Arlington High School Building Committee
Finance Subcommittee Meeting
Wednesday, March 16, 2022
Conducted by Remote Participation
4:00 PM – 5:00 PM
Agenda

3/16/2022 AHSBC Finance Subcommittee Meeting Meeting Materials

1. Motion to approve Consigli AHS Requisition #23 for \$1,709,783.89.
2. Motion to approve Change Order No. 12 for a total of \$93,617.67.
3. Motion to approve HMFH/BALA Addition Service Request Change to Natural Gas to Serve Temp Boiler for a total not to exceed value of \$10,450.00.

DRAWING NUMBER: **S2.2d**

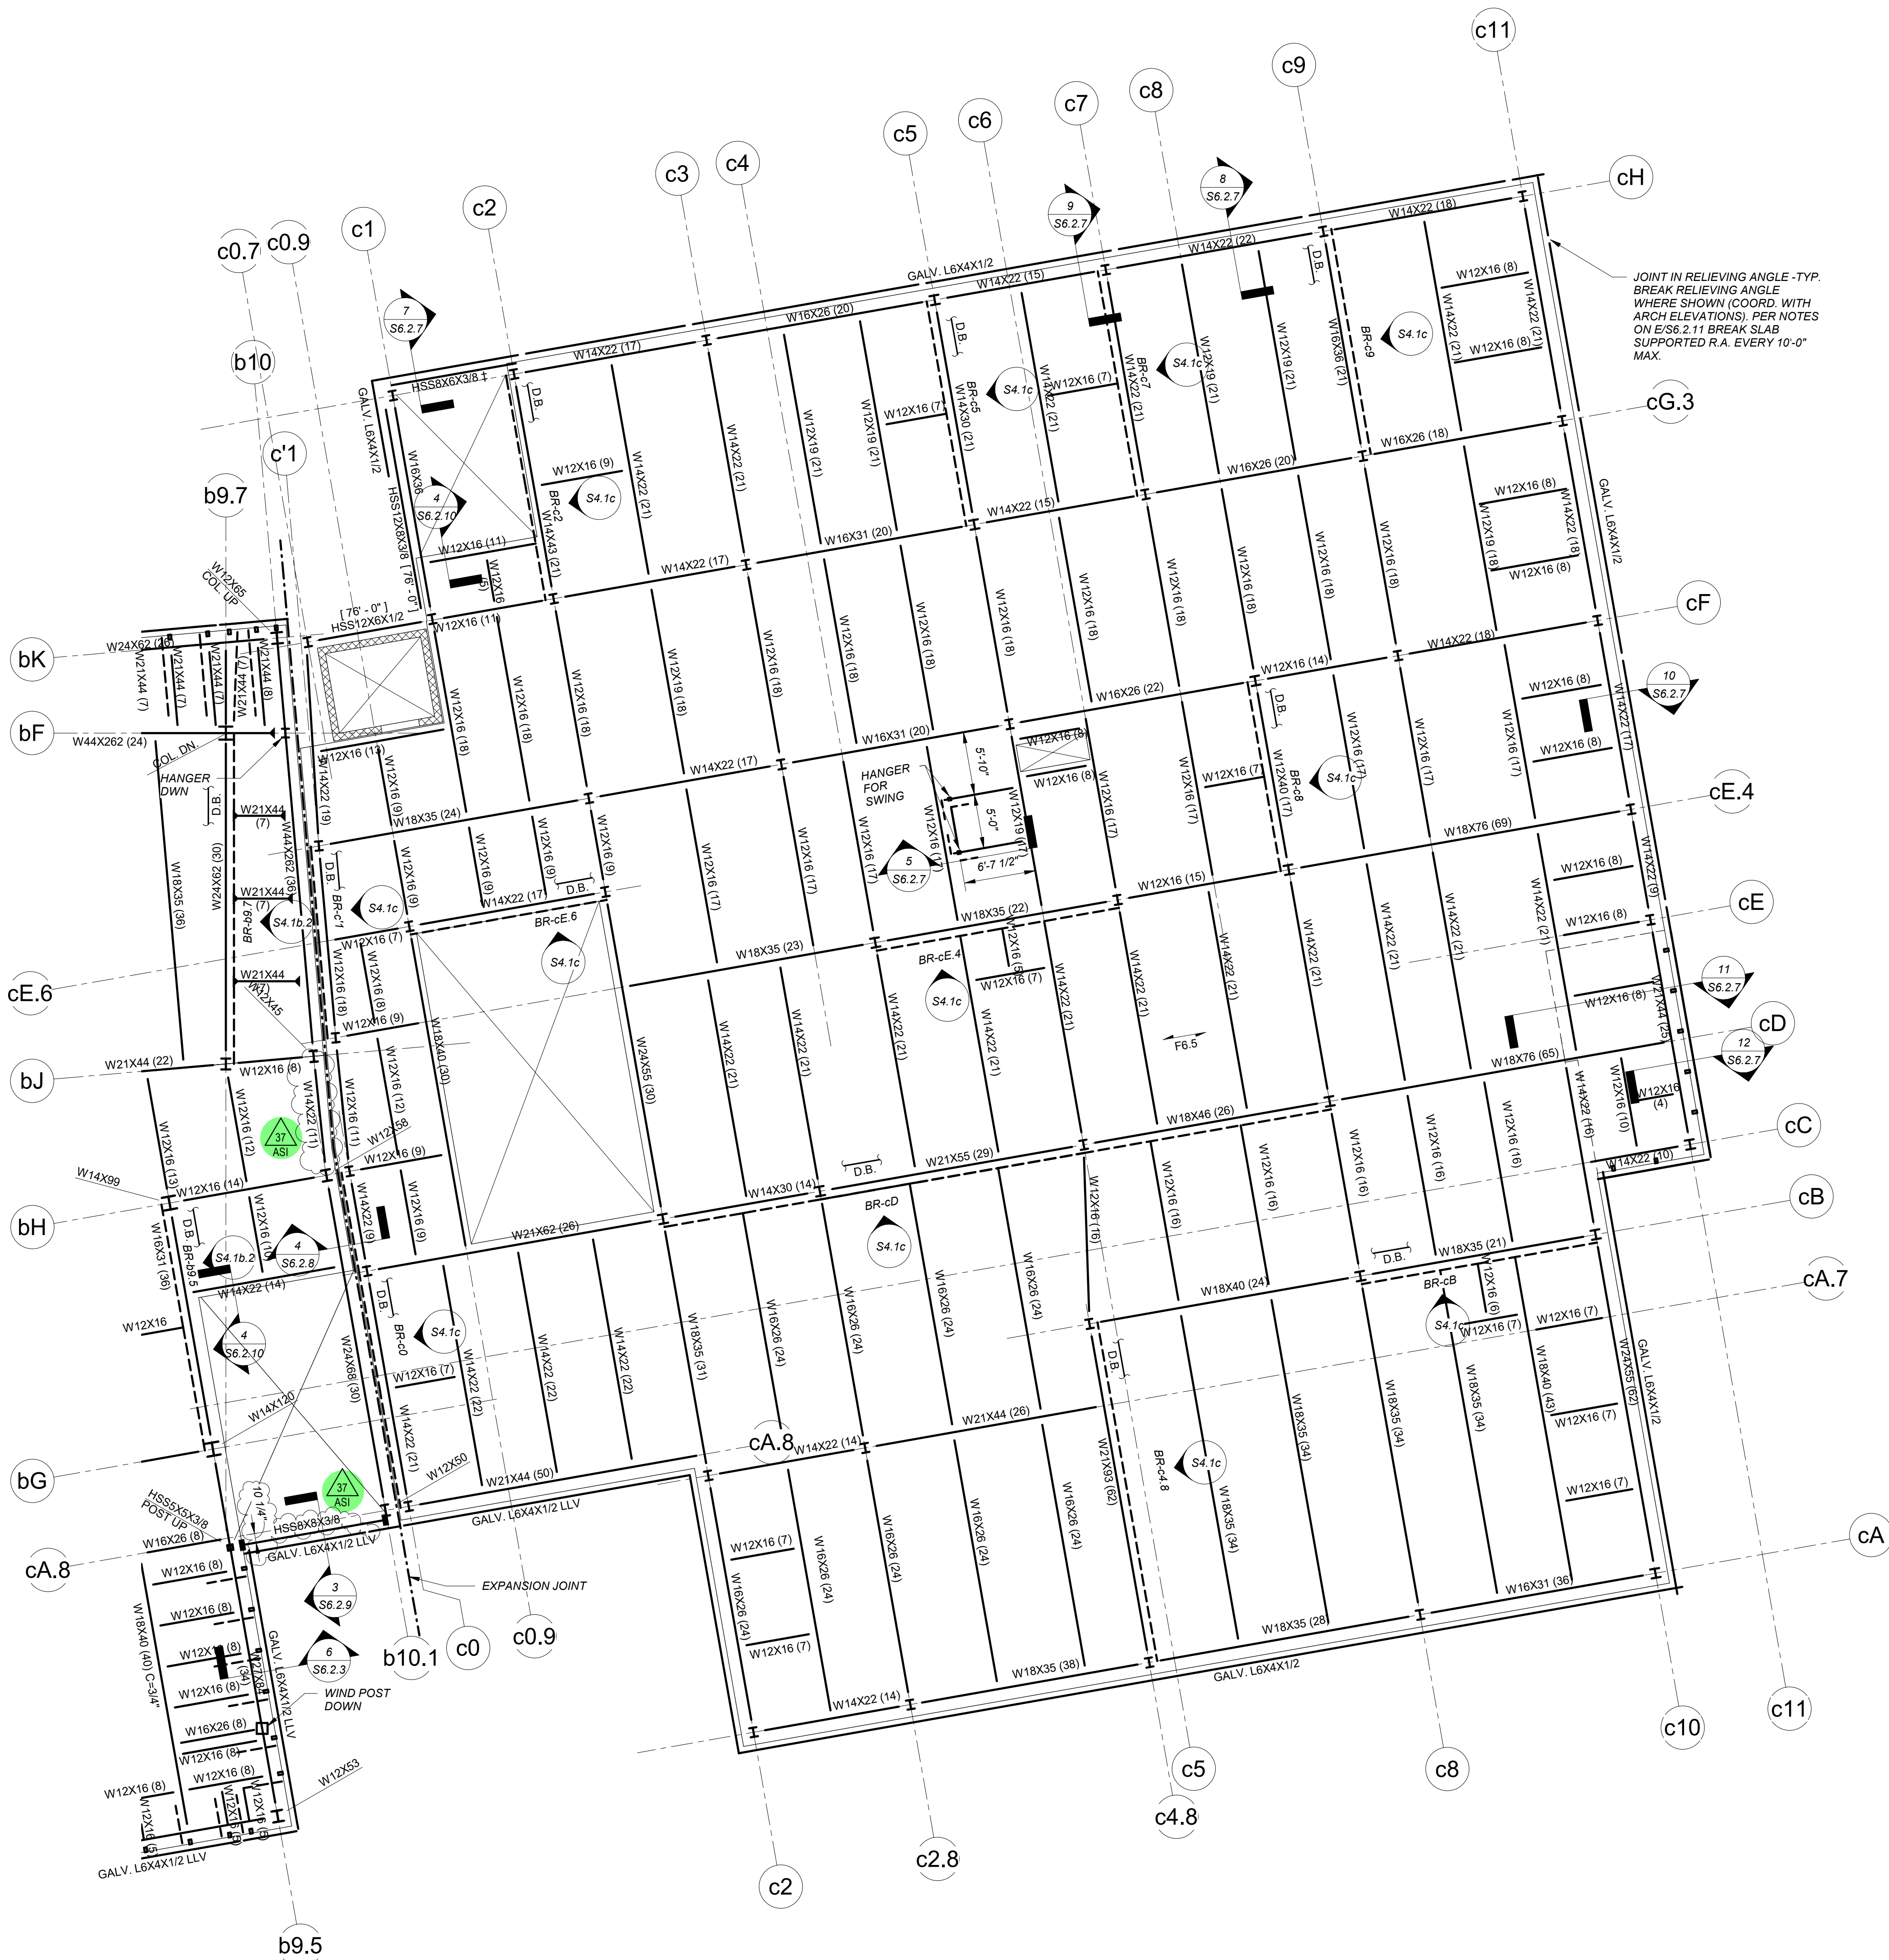
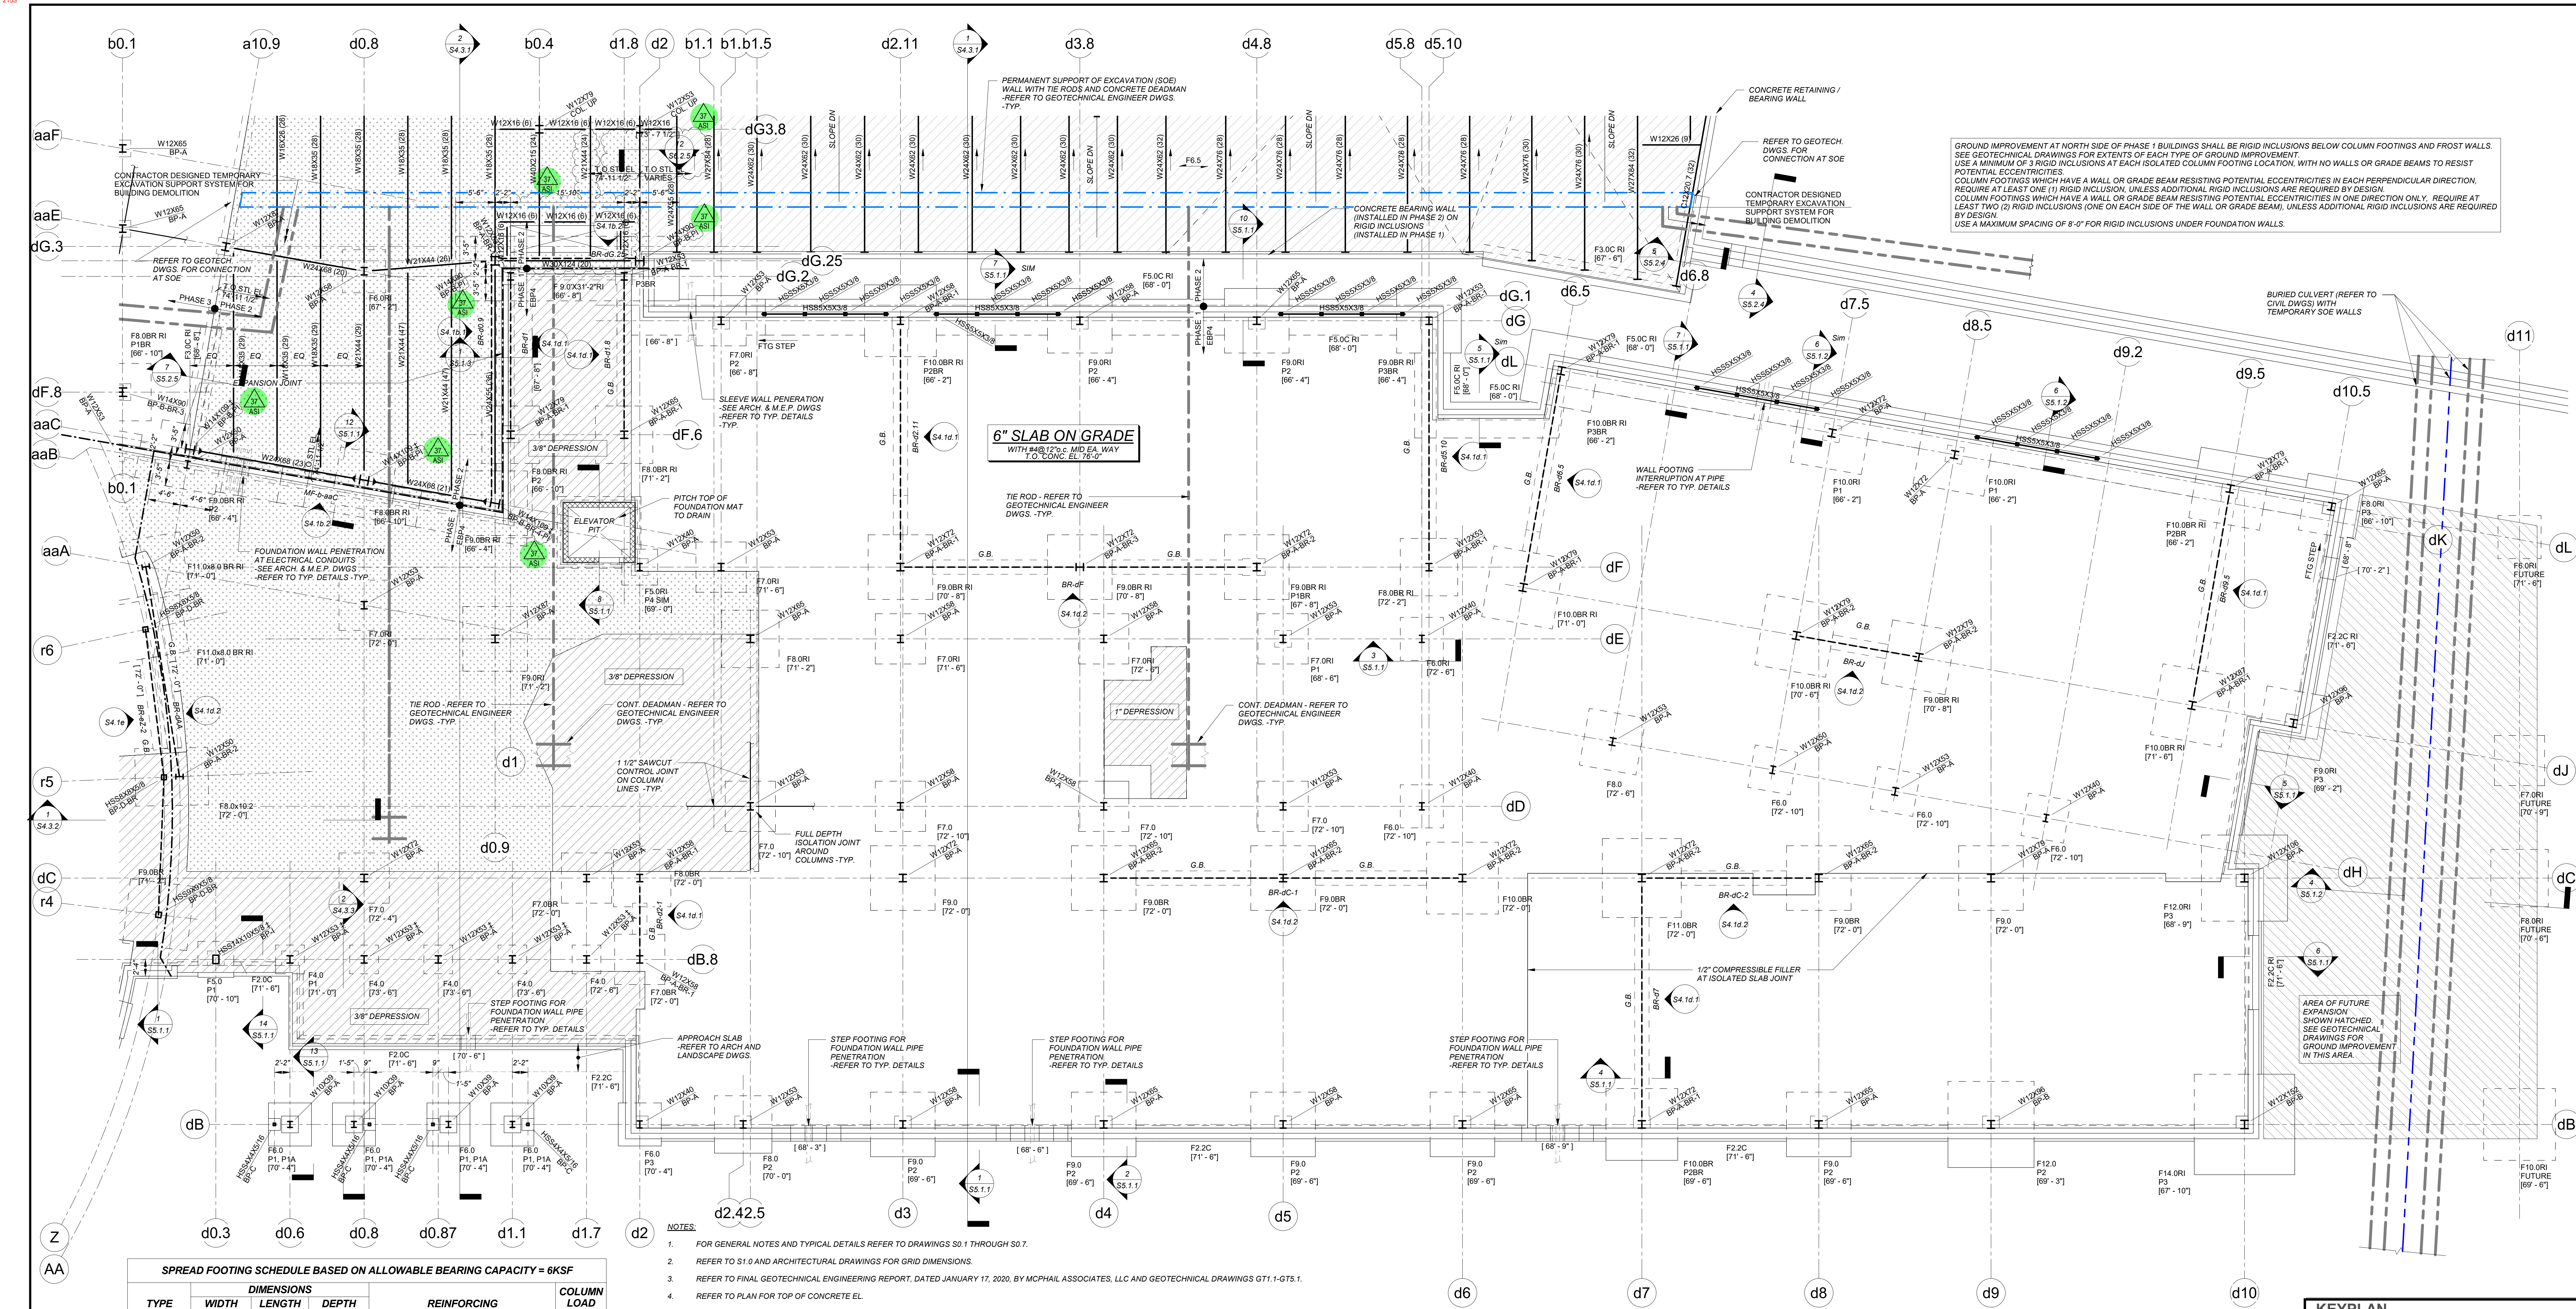
The Work shall be carried out in accordance with the following Supplemental Instructions issued in accordance with the Contract Documents without change in Contract Sum or Contract Time. Proceeding with the Work in accordance with these instructions indicates your acknowledgement that there will be no change in the Contract Sum or Contract time.

Various revisions to Phase 2/3 steel

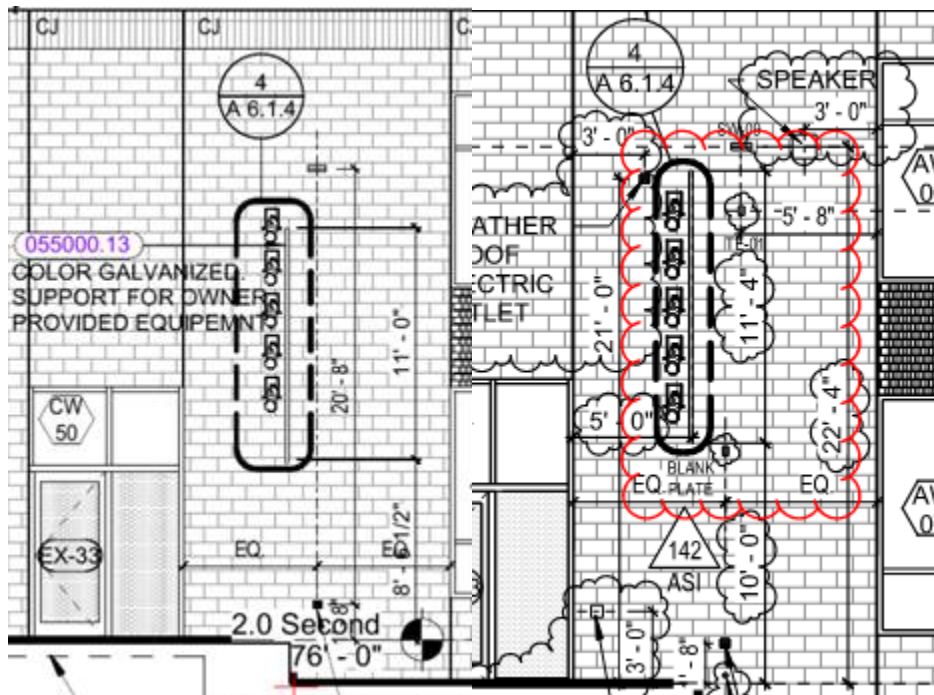
- 1.) The blocking for the steel channel that houses the light fixtures has already been installed per the contact drawings (8'6" AFF) see left snippet of original 6/A4.3.9. Dimensions didn't change much on the western side, but on the east side they change by about 16" vertically in ASI-142 (right snippet below). Masonry has already been installed over the blocking. Please review and advise if blocking and channel position to remain as currently installed.
